London Road, Crawley

Design Developments

Pre-Application Feedback

The information here is the itemised out feedback from the Design Officer on the pre-application submission information. The original comments are in black and our responses are in red.

Pre-App Scheme

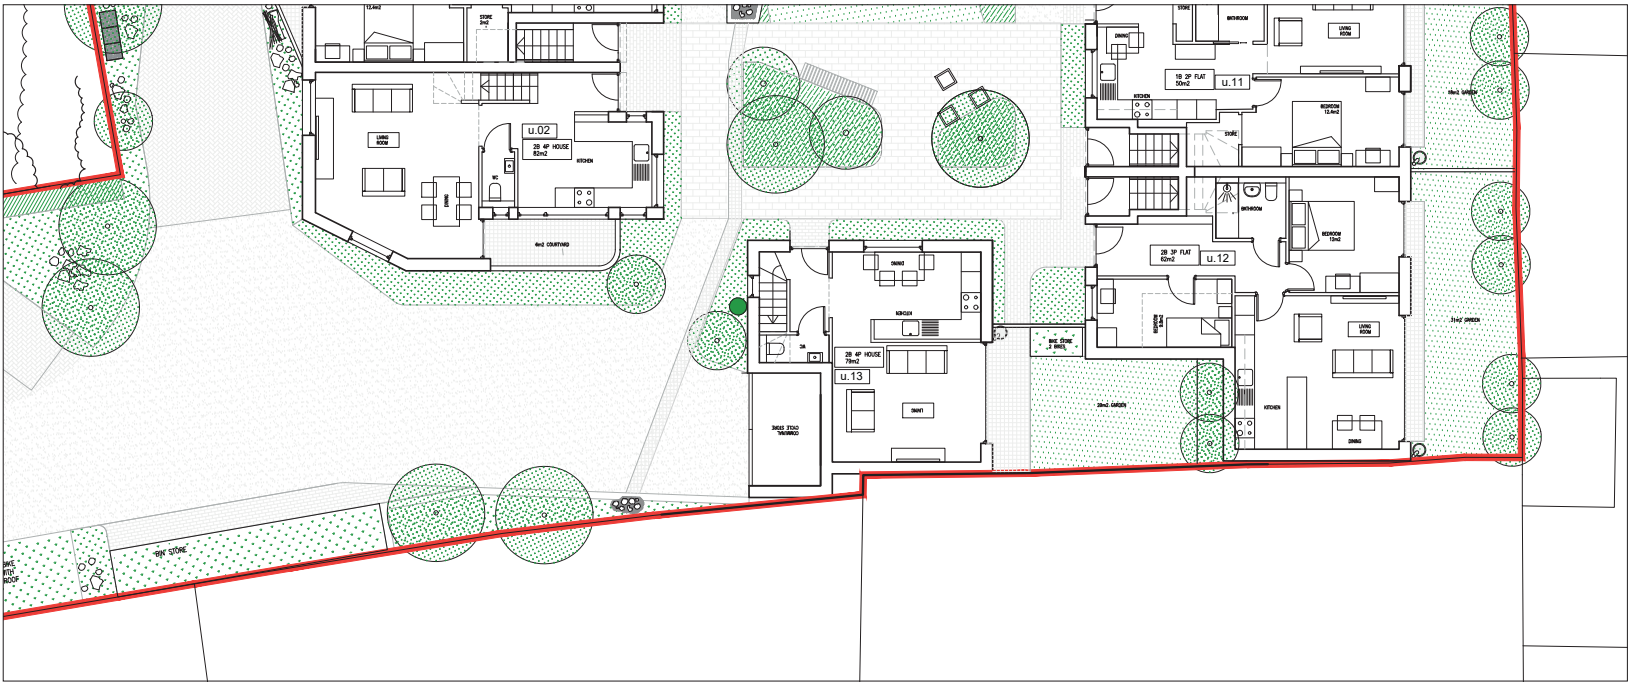
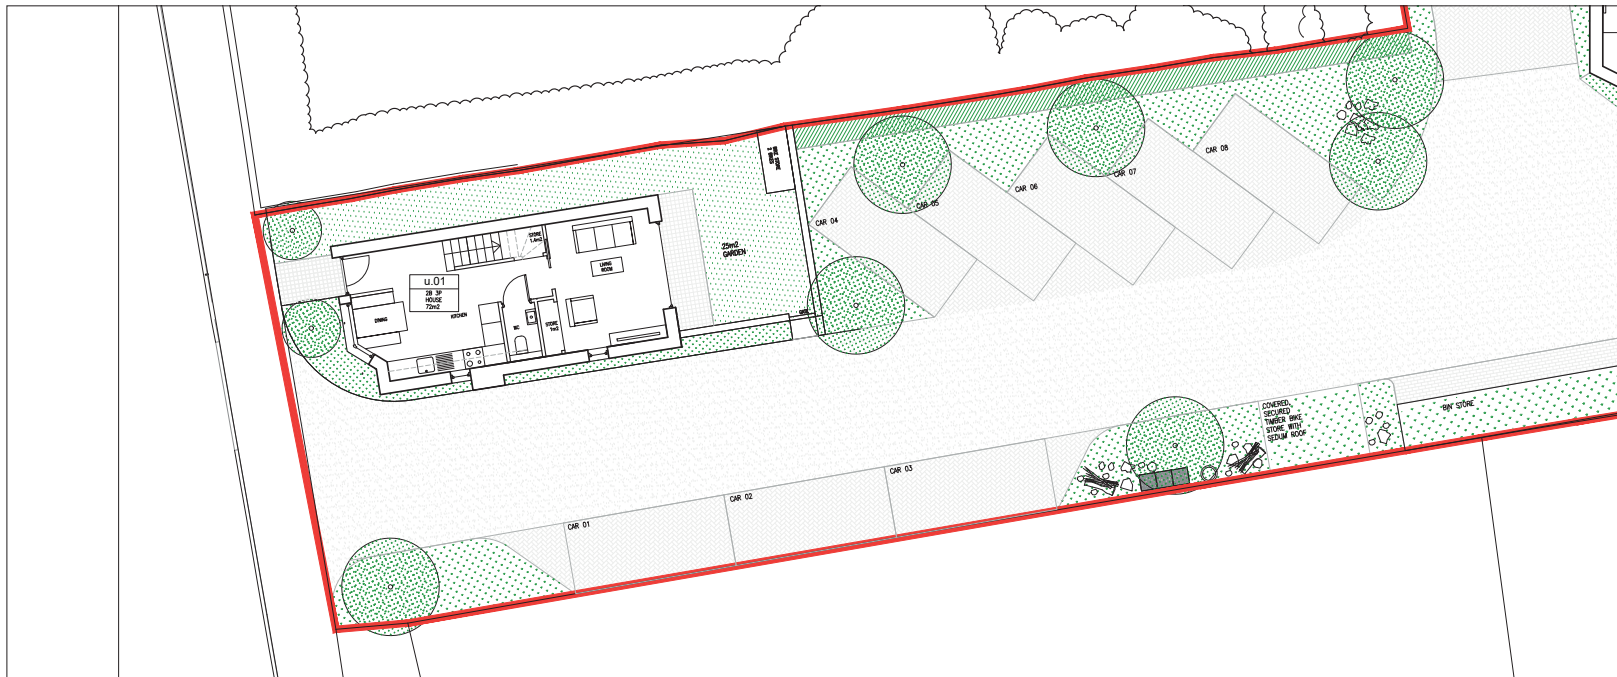
- Relationship between southern unit and boundary OK? Very close, impact on neighbouring amenity?
- Why whole building not slid back/eastwards? Why project forwards westwards? (Although agree with need for built form to act as visual end point to access route.)

- Amenity space / outlook oppressive; 2/3 storey wall on one side, boundary wall on the other.
- Bedroom onto garden? Lounge has little/no outlook/natural light; initially considered to be unacceptable due to poor amenity.

- Headlights shining in, all pedestrian access goes past the sole window.
- Problematic unit.
- Remove GF as separate unit, increase size of FF (maisonette?), put parking spot underneath (to reduce elsewhere), move cycle parking to face into courtyard, have kitchen and bathroom at GF (less outlook sensitive) and lounge/bedroom at FF.

- We agree with all these comments. We have therefore changed the southern block to a single 2 bed house with larger rear garden.
- This design change overcomes all the above comments.

Revised scheme with a greatly simplified southern block. This is now a single house and has been amended as per the officers advise and comments.

Pre-App Scheme

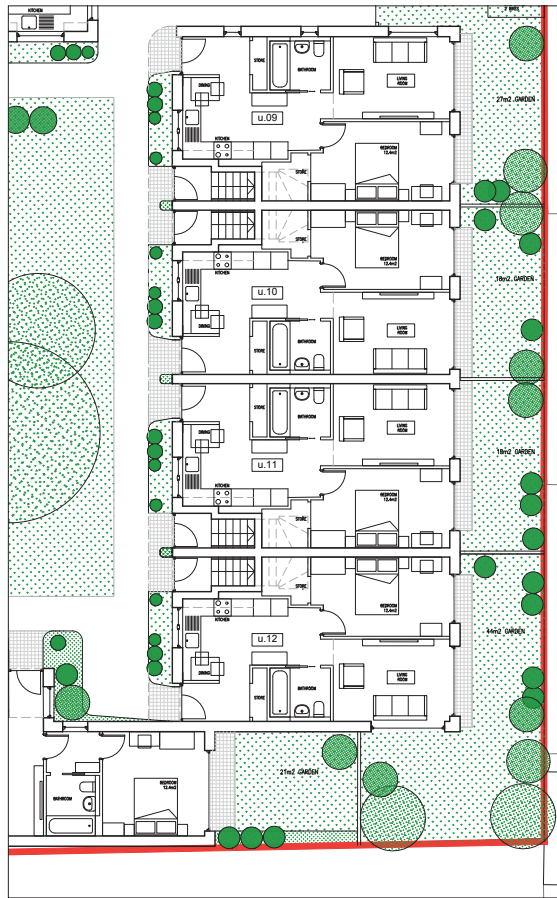
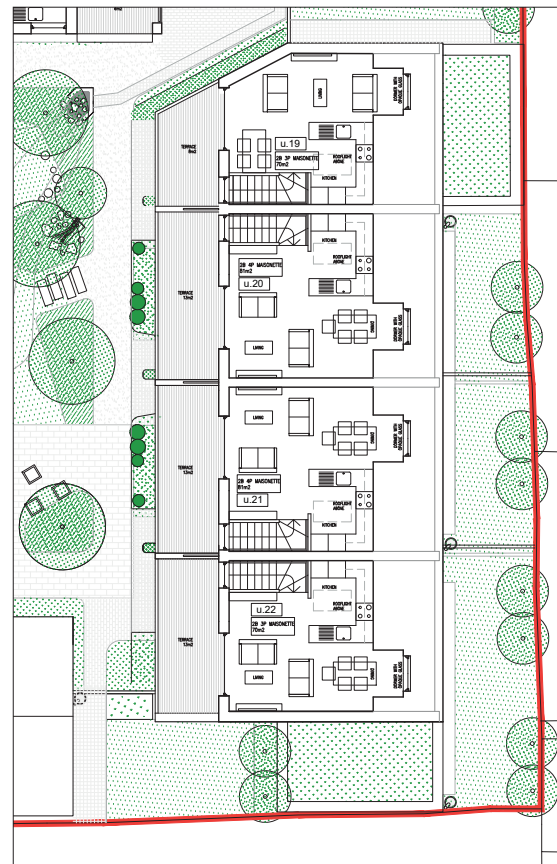
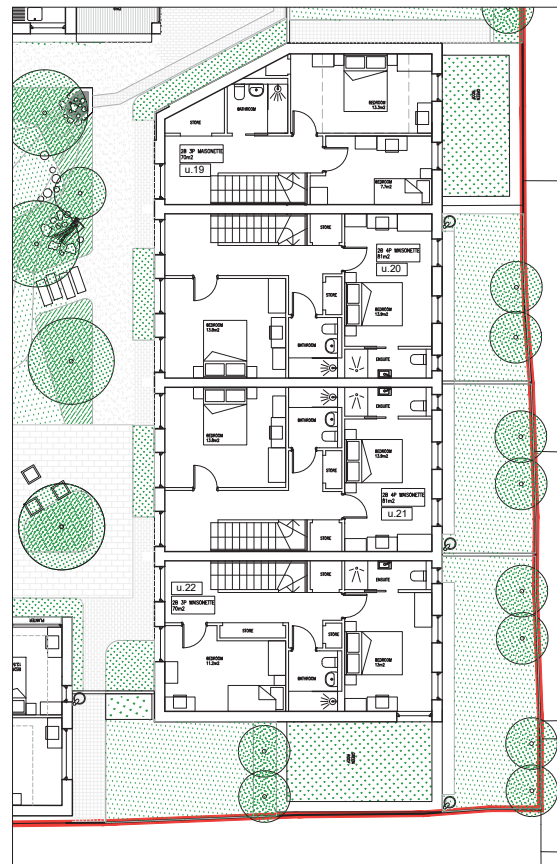
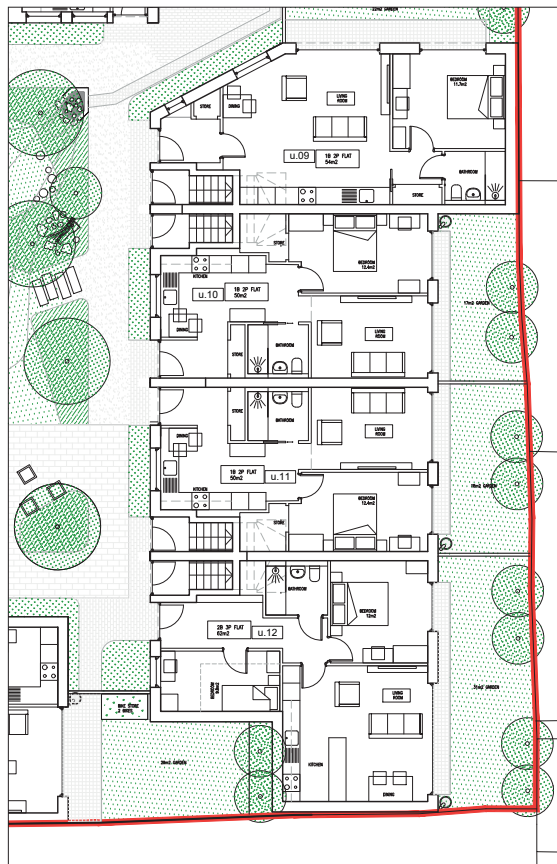
- Should be at ground floor so families make use of gardens; not much amenity space at roof level.
- We have amended the unit at the south of the ground floor to be a larger 2 bed flat where the garden space is largest.

- Could make roof balconies bigger; expand between units with privacy screens between – don't use rear area (overlooking).
- Agreed. We have expanded the terraces at second floor level into a single much more usable terrace at the front of the dwelling these are now all around 13-14m² whereas at pre-app they were only 7-8m².

- Change units to 2b maisonettes across GF and FF, with 1b flat at FF and 2F? (Position of internal staircases crucial to altering layout/unit type.)
- Instead of 1b GF unit w/ 2-storey maisonette above, could have 2-storey 2b GF/FF maisonette and smaller 2b 2-storey maisonette at FF/2F. (Positive gain of more family units.)

- We explored this option but have kept the majority of the dwellings with the 1 beds at ground floor. The option of flipping the arrangement led to significantly increased complexity to the scheme and we are trying to keep the layouts relatively consistent and as simple as possible.

- We believe that we have address the issue by amending the layout of the upper maisonettes by increasing the amenity space here.
- The unit at the southern end is now a 2 bed at GF where the garden is the largest.

Revised ground, first and second floor GAs with the advice incorporated

Pre-App Scheme

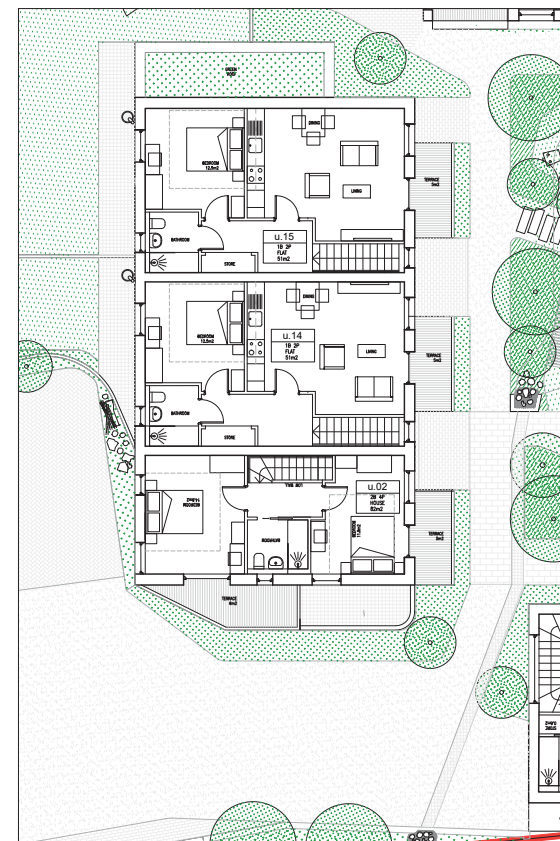
- 2-bed units need the garden spaces. Swap unit 3 with a 1b unit.
- The 2 bed dwelling has 17m² of amenity space split between GF and 1F.
- Extend landscaping to S of unit 2 – turning head doesn't need to be double width (?).
- Subject to tracking. Significant amount of landscaping added along this area of the site to the frontage.
- Provide more defensible space and communal landscaping.
- Agreed. We have developed a full landscape scheme with Match Landscape Architects. This significantly increases the amount of landscaping / trees provided on site and reduces the access width to a minimum.
- Bike store “within” unit 2 should be removed – noise/disturbance. (Consider larger store within courtyard-facing elevation of southern GF unit, as above.)
- Bike store removed as per advice.

Revised ground, first GAs with the advice incorporated
